1.0 APPLICATION SUMMARY

Planned Development (PD) 13-0939 (as most recently modified by MM 22-1116) is approved for two development options: (A) an indoor/outdoor recreation facility, a child-care center, and voluntary pre-kindergarten program to serve up to 322 total children; and (B) an indoor/outdoor recreation facility with a pool, playground, and a 150 student special needs school for grades K-12. The applicant is requesting a modification to reduce the incompatible buffering and screening requirements for Option B and to remove the requirement to construct a sidewalk in the public right-of-way to the north of the property for both options.

APPLICATION NUMBER: PRS 25-1052

SHEET
2
OF
3

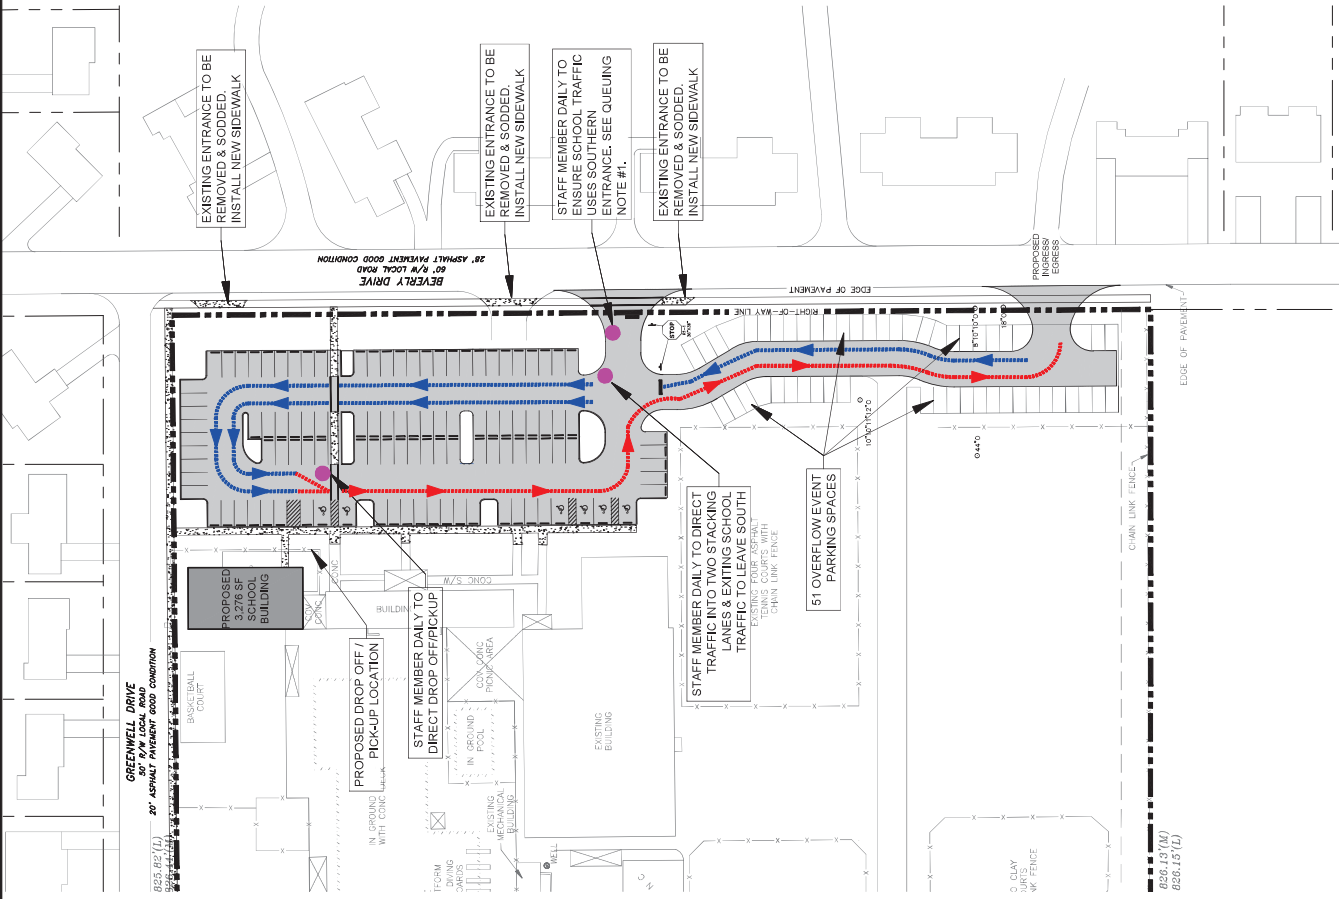
- f. Access management, vehicle queuing, and staff placement shall occur consistent with the Queuing Plan (Sheet 2 of 3). Modifications to these plans may be submitted in accordance with Condition 3, above, or as otherwise approved by Hillsborough County Public Works.

3. In order to ensure safe and efficiency access to the site, the school shall ensure that staff is present (as indicated on Sheet 2 of 3) to oversee drop-off and pick-up activities, as well as direct school traffic consistent with these restrictions and the Queuing Plan.
